**PG&E Topock
Compressor Station
Needles, California**

**Revised Groundwater Corrective Measures
Implementation/Remedial Design Work Plan
for SWMU 1/AOC 1 and AOC 10**

November 2011

Subject: Revised Groundwater Corrective Measure Implementation/Remedial Design Work Plan for SWMU 1/AOC 1 and AOC 10, PG&E Topock Compressor Station, Needles, California (Document ID: PGE20111104A)

FIGURE 2-1a
CONCEPTUAL REMEDY SITE PLAN
CALIFORNIA PORTION
 CORRECTIVE MEASURES IMPLEMENTATION/
 REMEDIAL DESIGN WORK PLAN
 PG&E TOPOCK COMPRESSOR STATION
 NEEDLES, CALIFORNIA

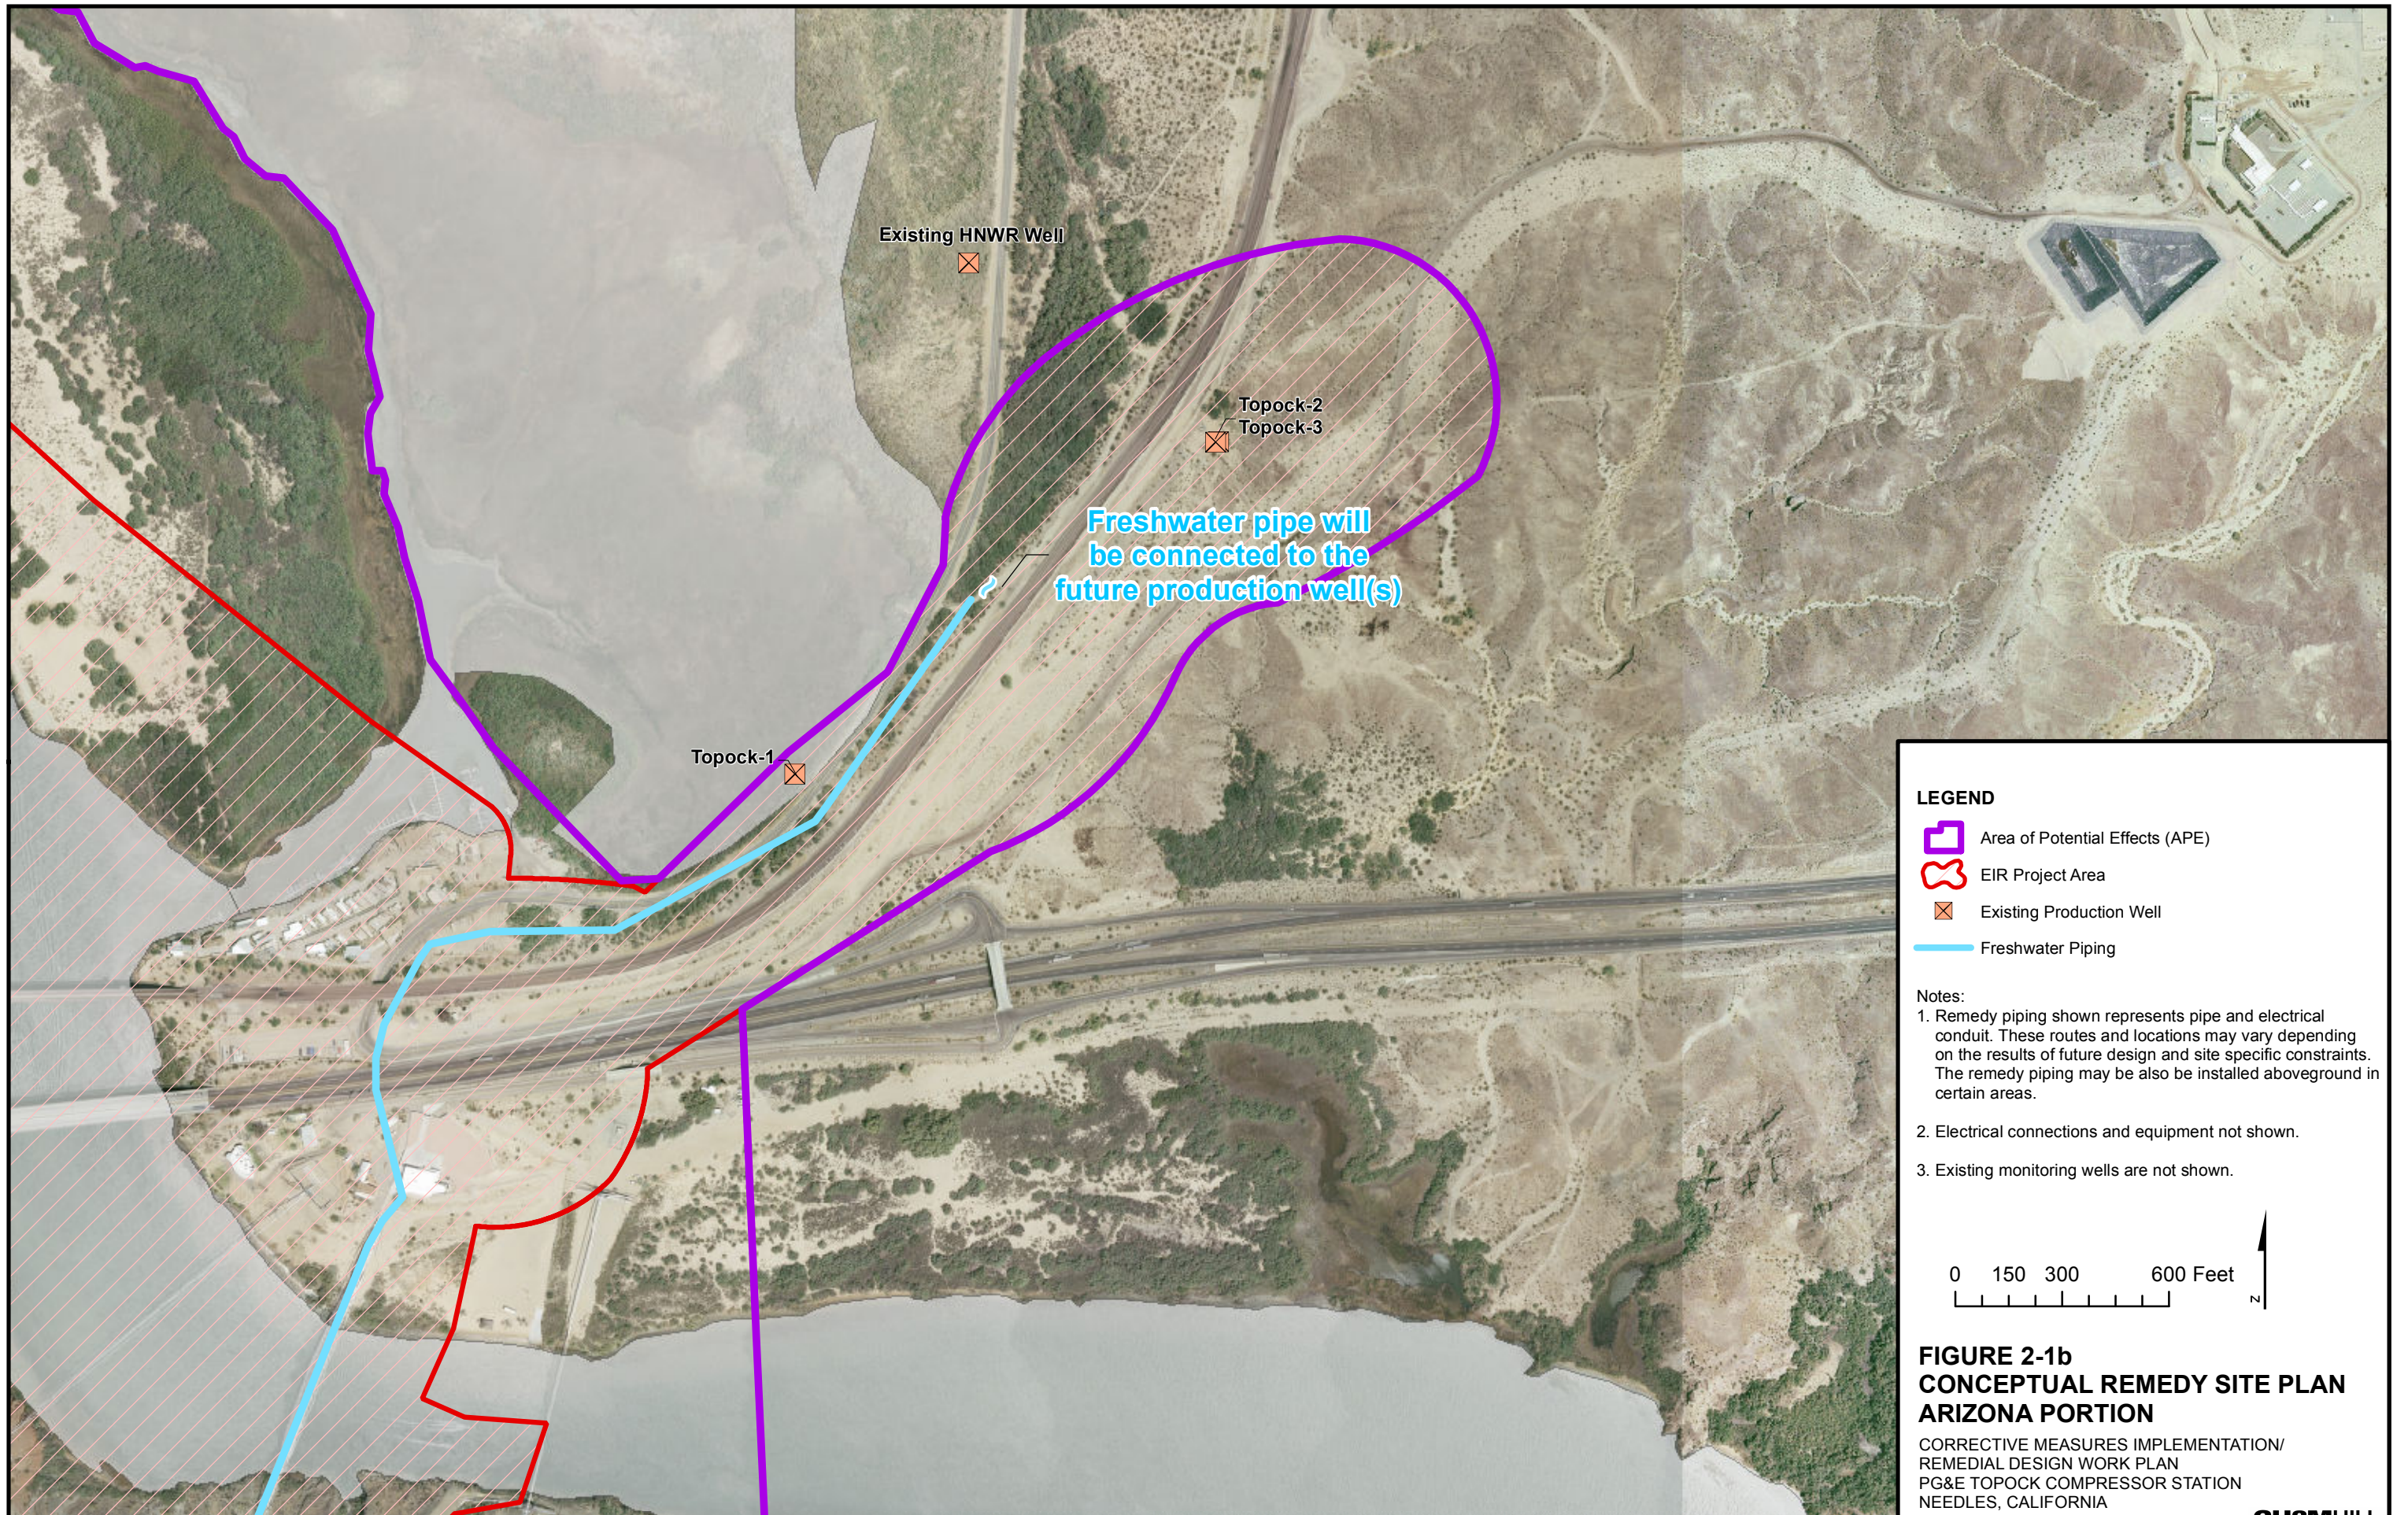
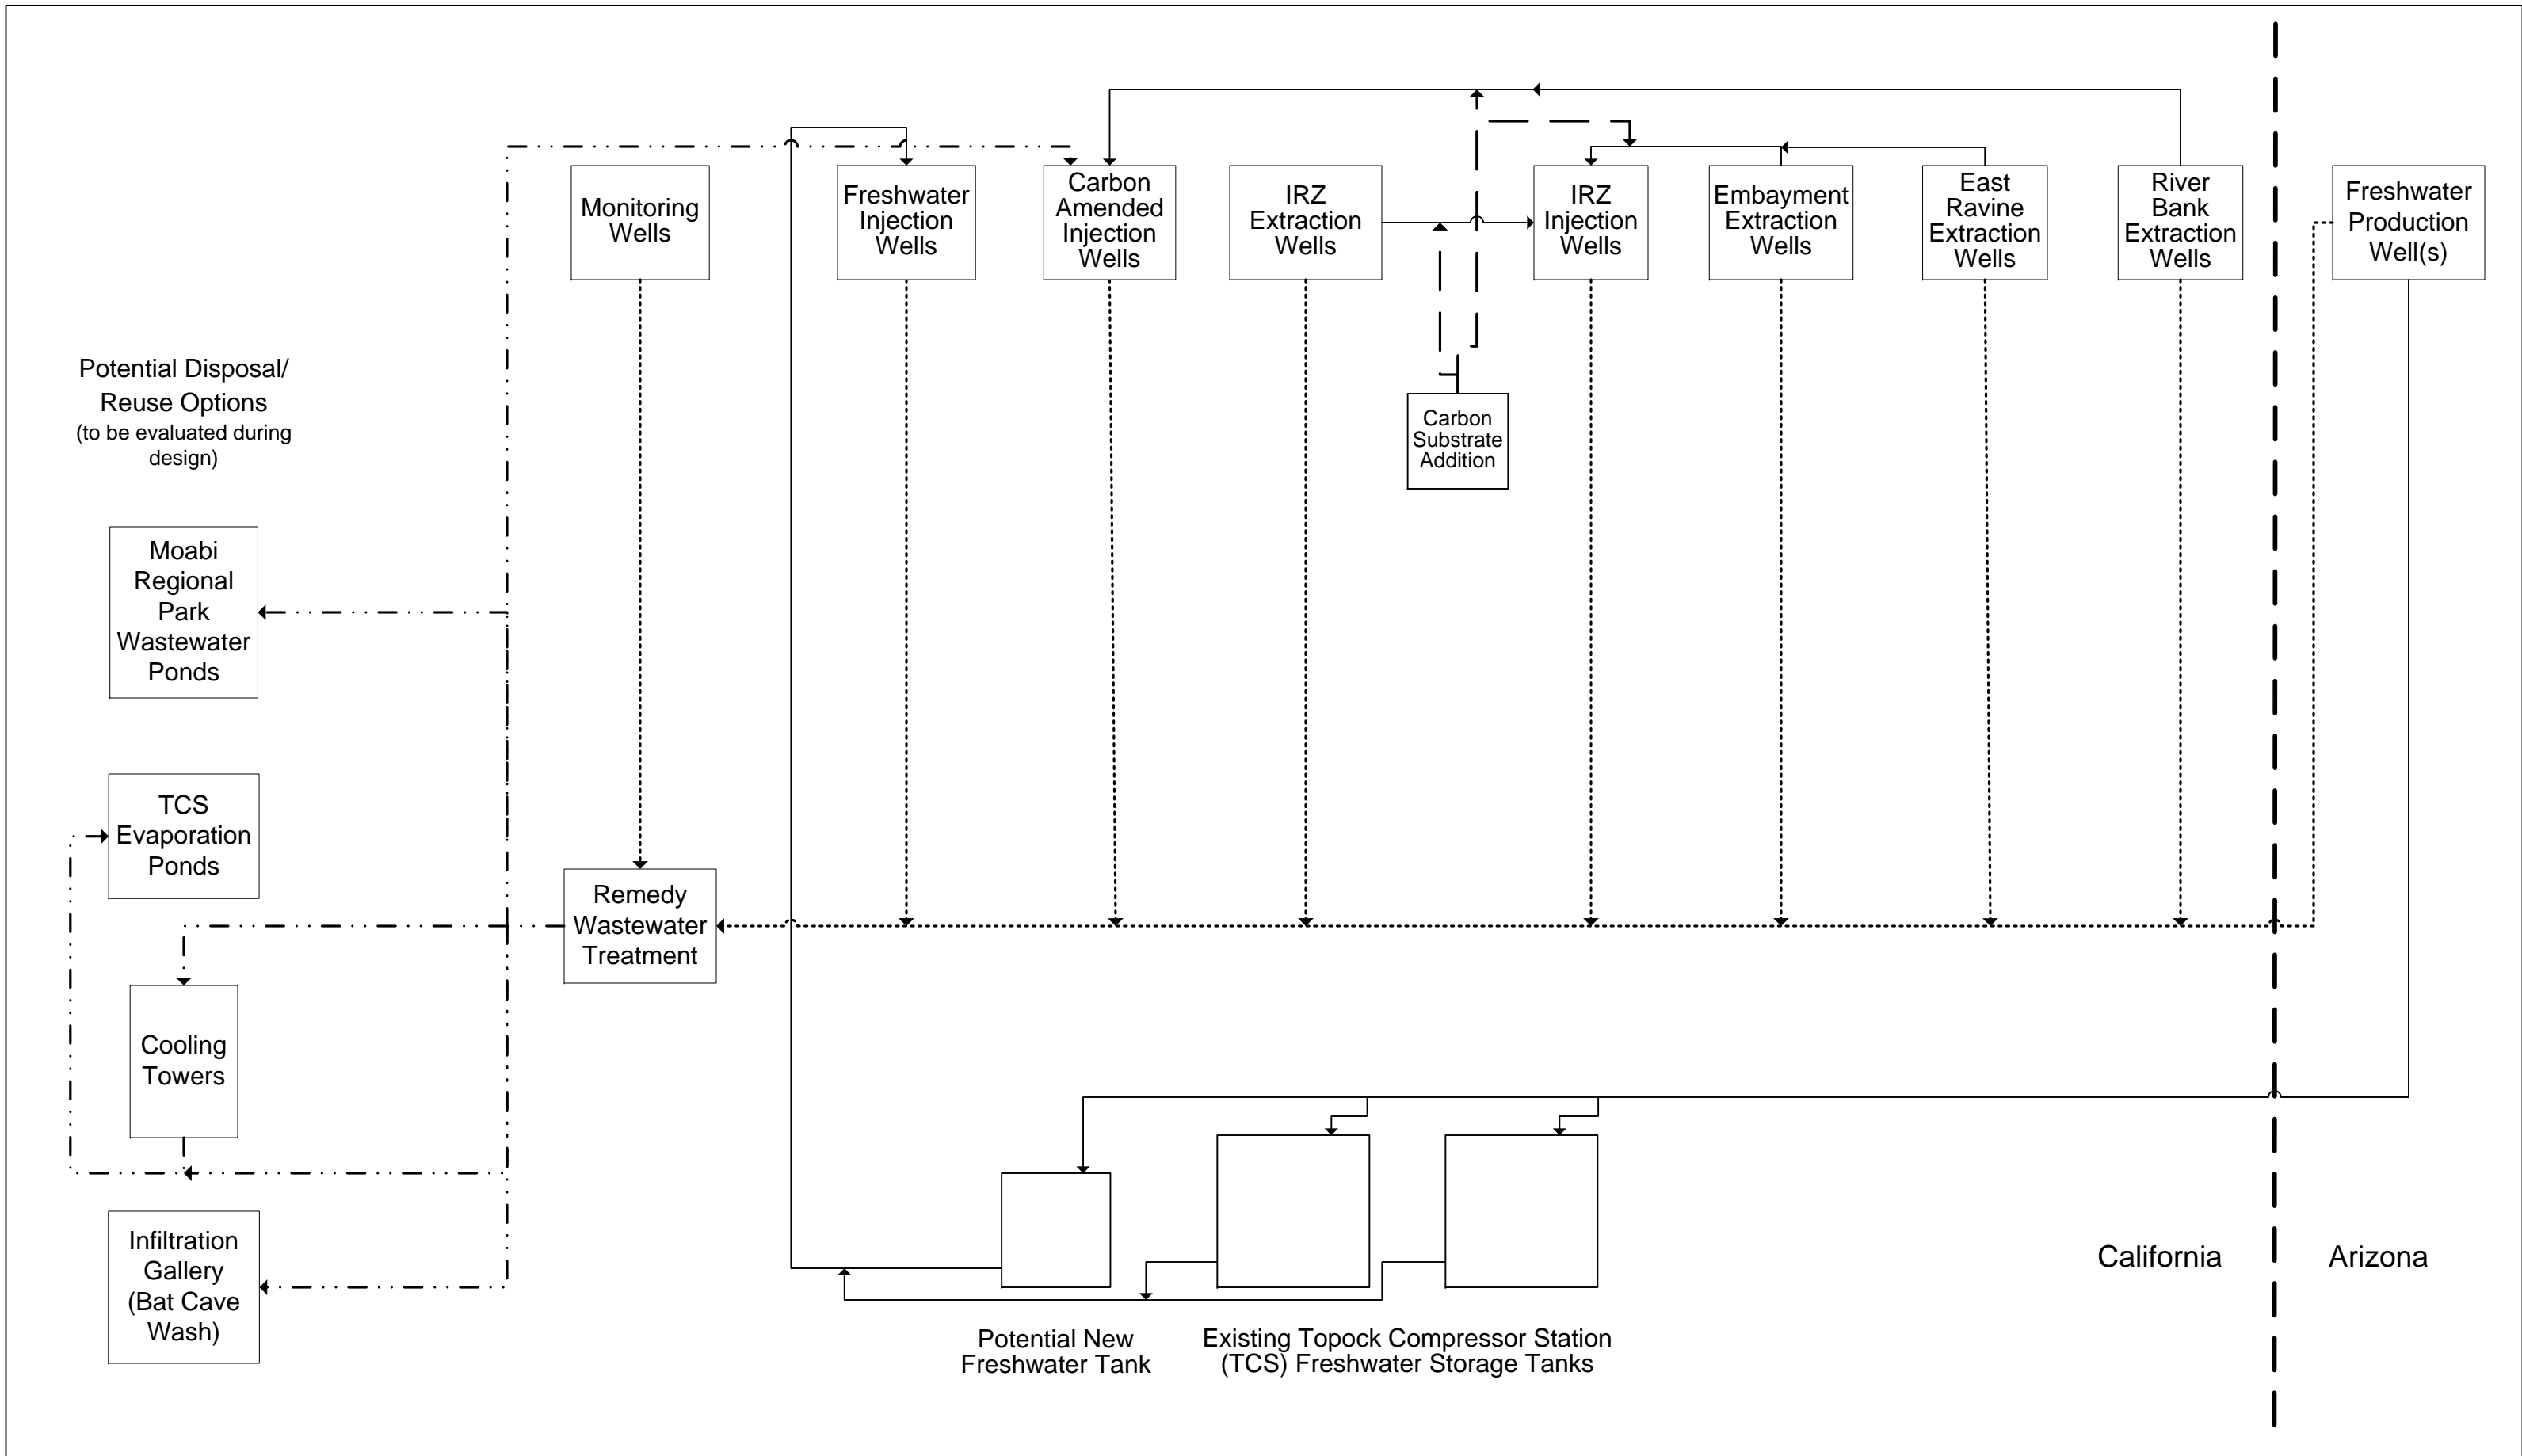
231	DTSC-101	Figure 2-1a, Conceptual Remedy Site Plan California Portion		California Department of Toxic Substances Control	The CMI should indicate why it is necessary to have freshwater and wastewater pipelines located in Bat Cave Wash. Are these lines redundant and can the waters be transported along the other proposed segments?	At this conceptual stage, the portion of the freshwater and wastewater pipelines in Bat Cave Wash is envisioned to be part of a looped system. The loop system increases system redundancy (e.g., freshwater supplied from Bat Cave Wash or National Trails Highway), increases system flexibility to accommodate future changes (e.g., able to serve future wells), and reduces friction loss and electricity costs. Wastewater from maintenance of the injection well in the I-40 median will be piped back (via Bat Cave Wash) to the compressor station for treatment prior to reuse/disposal.	DTSC does not understand how the addition of +1000 feet of water conveyance piping would reduce friction loss and electricity costs? Aren't water conveyance pipelines uni-directional? Would not additional piping create a greater pressure drop and potentially requiring more power to pump the water around? If they are shut off by valves, what would be their purpose other than possibly increasing the likelihood of damage and leaks? Although DTSC understands PG&E's desire to have "flexibility for future changes," Agencies must be mindful that additional piping is additional intrusion into a landscape which the project is supposed to minimize.		Additional analysis will be presented in the 30% design.

232	MWD-8	Figure 2-1a - Conceptual Remedy Site Plan California Portion		Metropolitan Water District of Southern California	This figure includes similar symbols for freshwater injection wells and injection wells for carbon amended water. It is difficult to discern the difference between these wells on the figure because of the close similarity in symbols. It is suggested to use dissimilar symbols for these wells.	Figure 2-1a was revised to address this comment.		Noted.	Comment addressed.
233	DTSC-102	Figure 2-3, Conceptual remedy wastewater treatment schematic diagram	"Solids for Disposal" and "Water Storage"	California Department of Toxic Substances Control	Should the "Water Storage" box be renamed to "Untreated Wastewater Storage"?	Figure 2-3 will be revised.	Okay.		Comment resolved
